GN AR # 01 – CARBIOU MONITORING	
Department	Environment
Organization	Government of Nunavut
Subject/Topic	Caribou Monitoring
Terms and Conditions	NIRB Project Certificate No. 005 (Amendment 3) Terms and Conditions 54(d)(ii), 58(f), 53(b), 54(b), and 58(b)
References	<ul style="list-style-type: none"> • Baffinland Iron Mines Corporation (BIMC). (2016). Terrestrial Environment Mitigation and Monitoring Plan. • Environmental Dynamics Inc (EDI). (2015). Mary River Project Terrestrial Environment 2014 Annual Monitoring Report. • Environmental Dynamics Inc (EDI). (2016). Mary River Project Terrestrial Environment 2015 Annual Monitoring Report. • Environmental Dynamics Inc (EDI). (2017). Mary River Project Terrestrial Environment 2016 Annual Monitoring Report. • Environmental Dynamics Inc (EDI). (2018). Mary River Project Terrestrial Environment 2017 Annual Monitoring Report. • Environmental Dynamics Inc (EDI). (2019). Mary River Project Terrestrial Environment 2018 Annual Monitoring Report. • Environmental Dynamics Inc (EDI). (2020). Mary River Project Terrestrial Environment 2019 Annual Monitoring Report. • Environmental Dynamics Inc (EDI). (2021). Mary River Project Terrestrial Environm

Figure 1. Maps showing: (a) Helicopter flights made in June 2021, as reported in EDI (2022a) and (b) Movements of 7 collared caribou during the same month (Government of Nunavut, unpublished data).

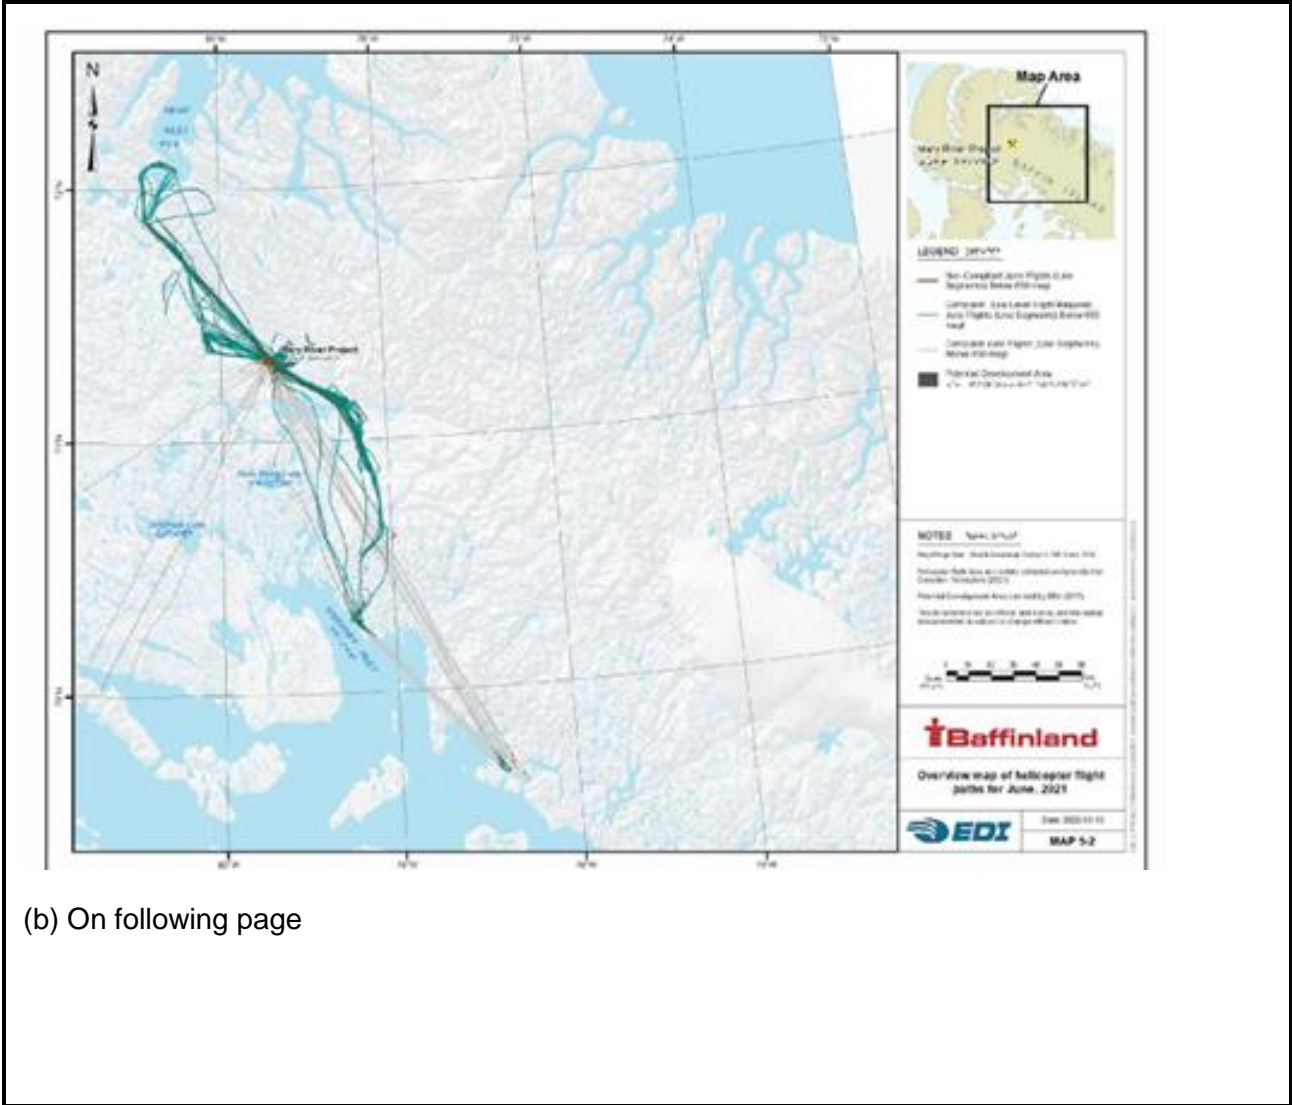
Additionally, in 2021, a small sample of north Baffin caribou were collared by the GN. Although the collars were not deployed in the vicinity of the Project for the purpose of studying Project-related effects, it is apparent that the movements of some individuals overlapped significantly with the Project activities reported in the 2021 Annual Report, such as low-level helicopter flights during calving and post-calving periods in June, July, and August (Compare figures 1-3 below with Maps 5-2 to 5-4 in EDI 2022a).

These data from collars and incidental observations show that interactions between caribou and the Project are occurring. However, these interactions are undetected, unstudied, and unmitigated under the Project's current monitoring regimen, which involves infrequent snow track and HOL surveys that are only capable of observing caribou over short distances close to the PDA. The Proponent claims that snow track and HOL surveys can:

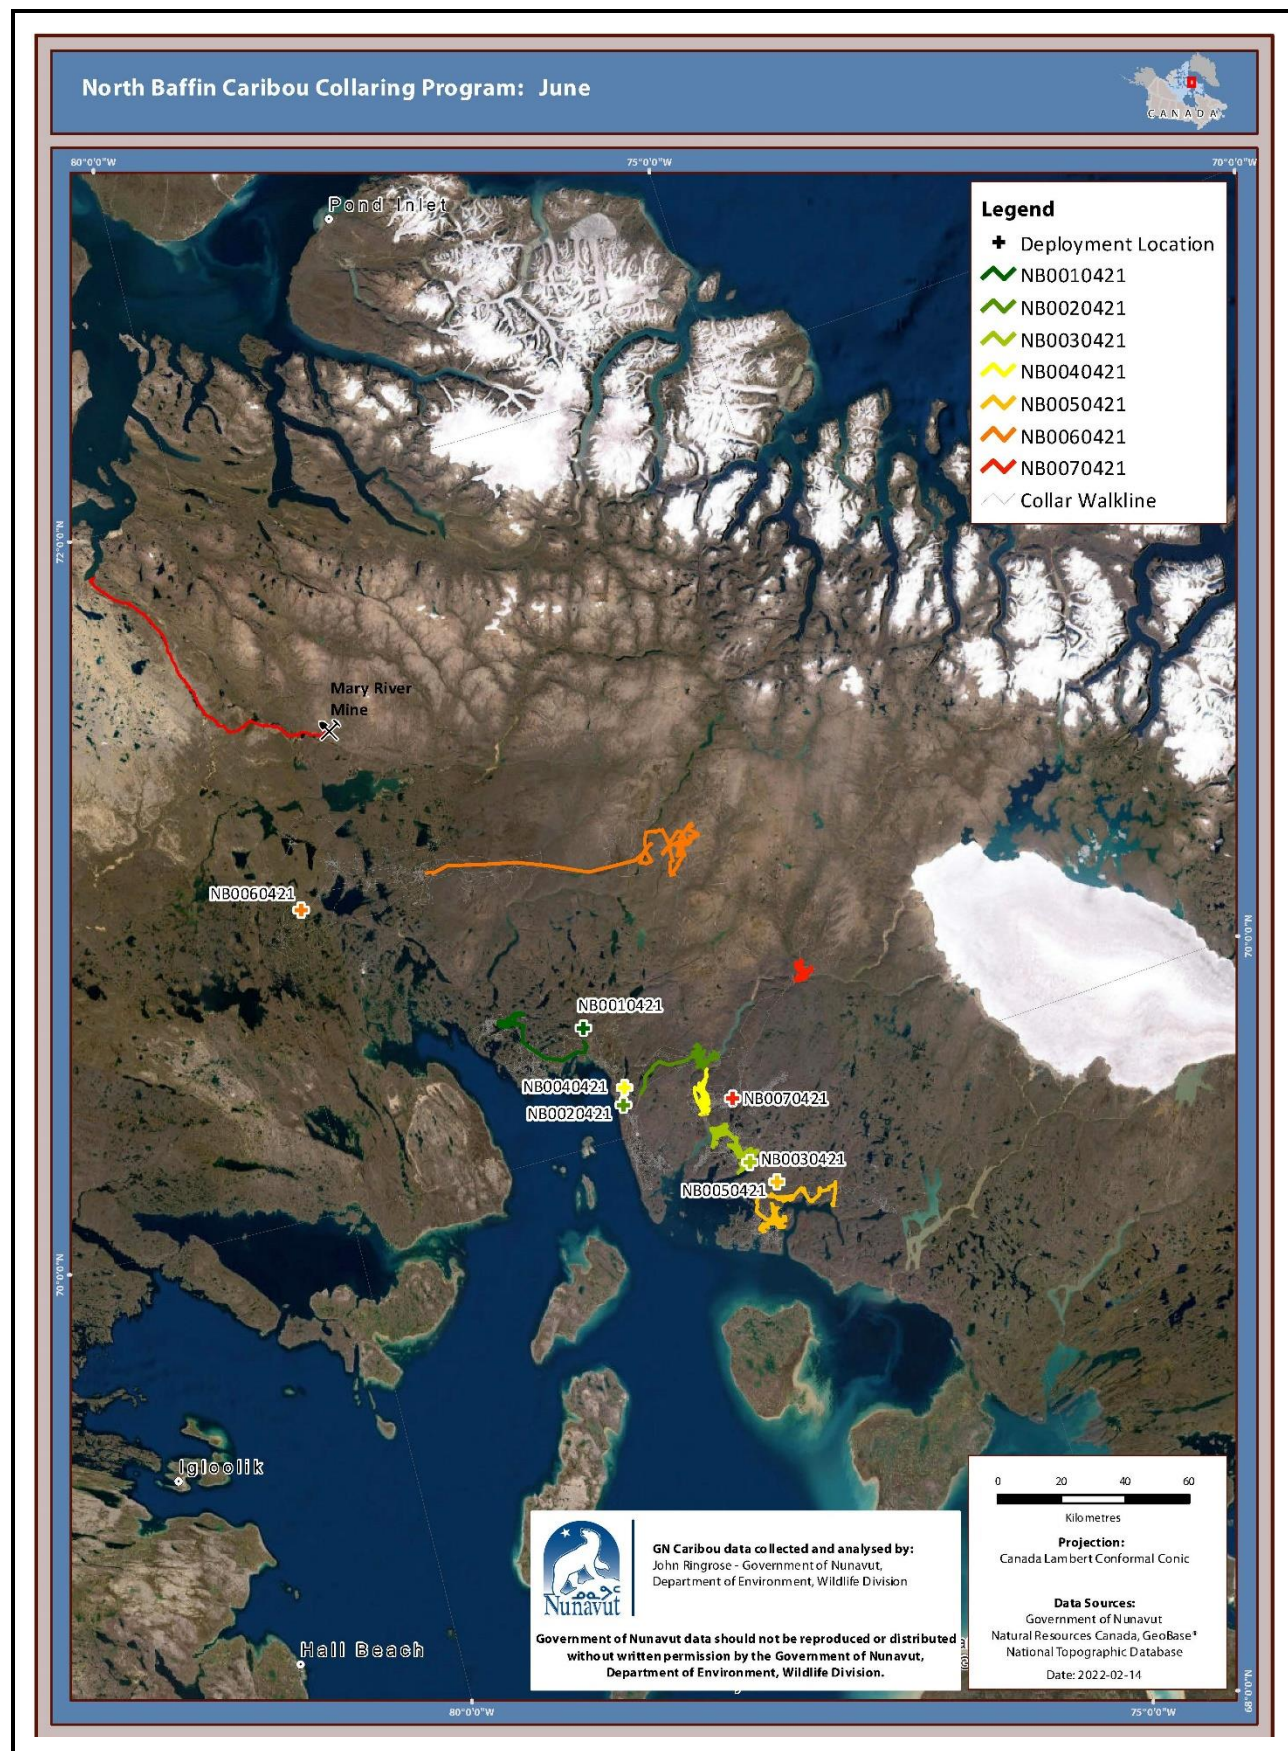
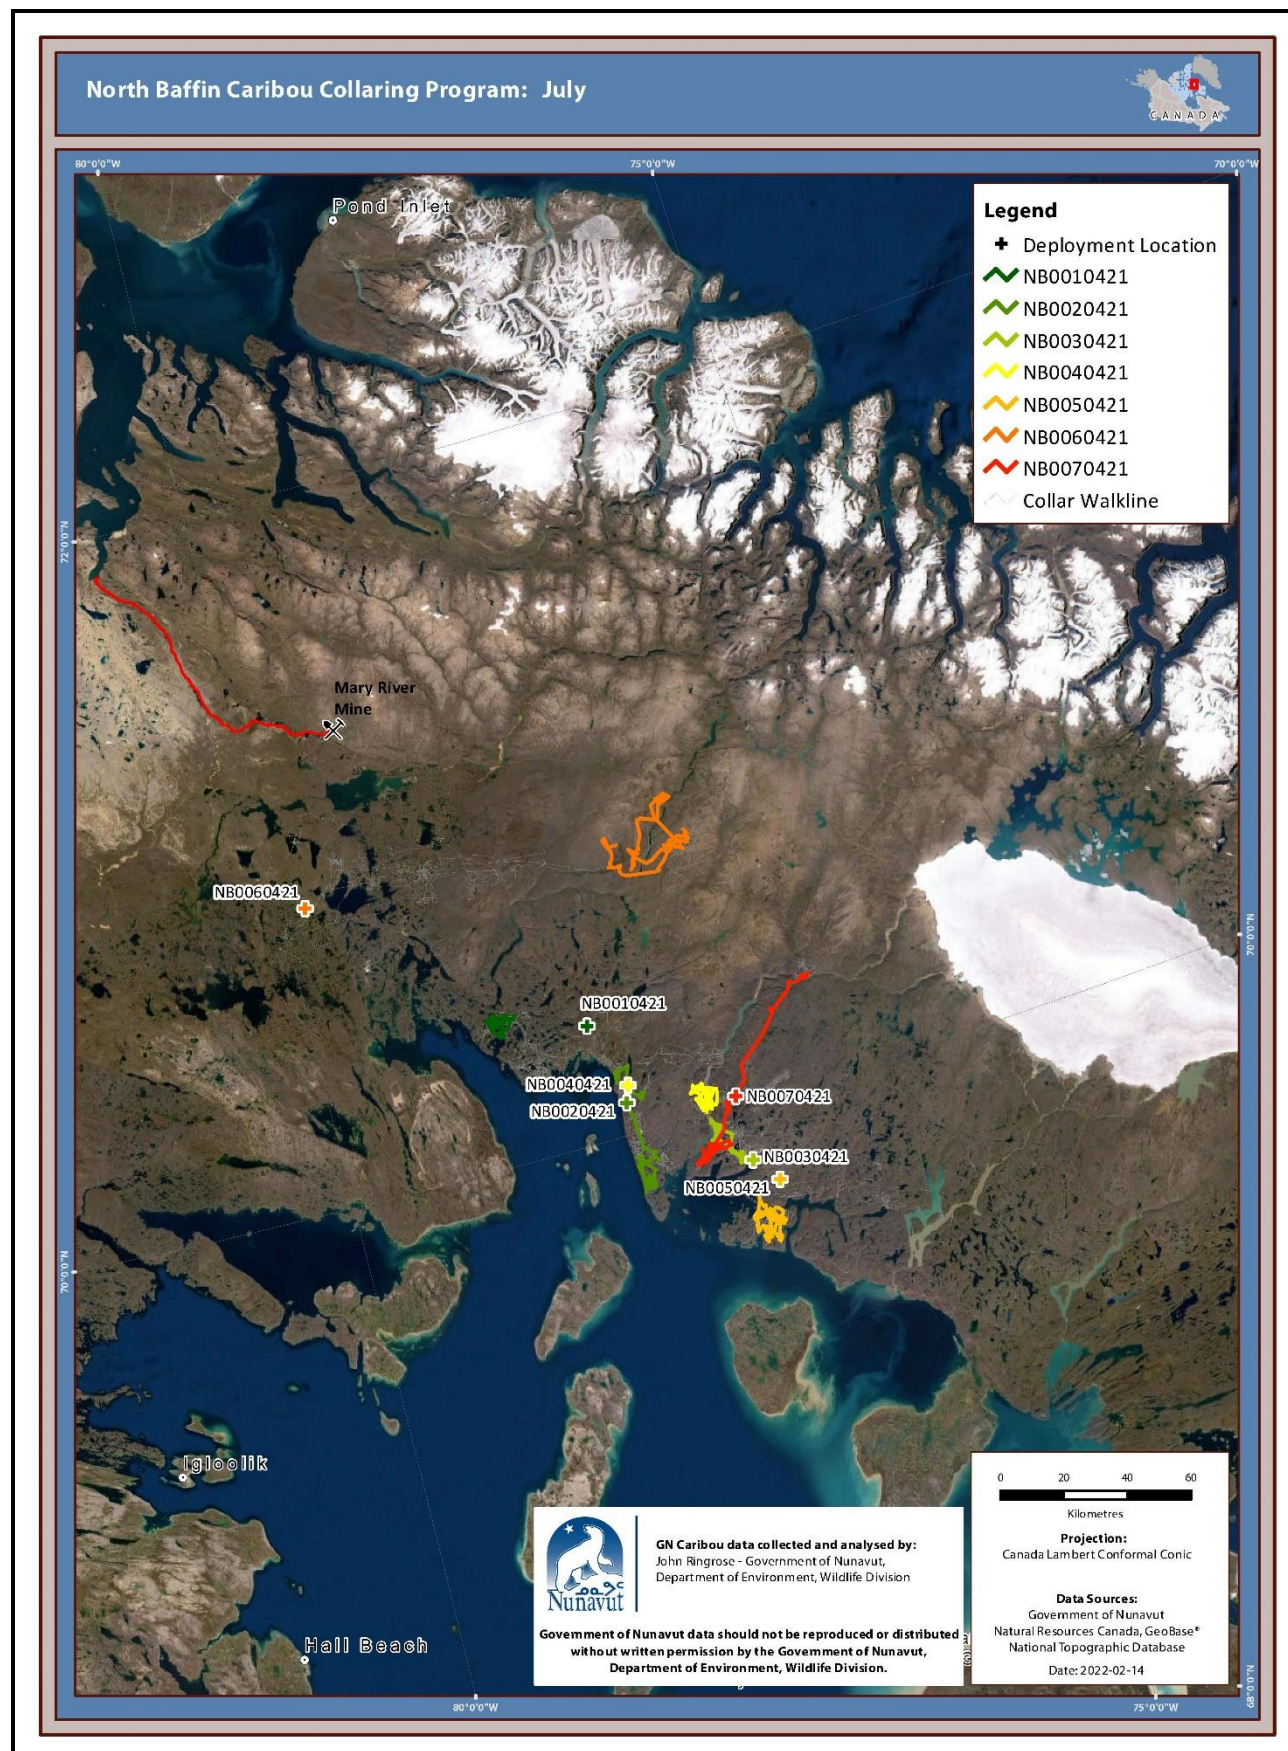
July	See Figure 2 (b) below	Map 5-3 (EDI 2022a)
August	See Figure 3 (b) below	Map 5-4 (EDI 2022a)
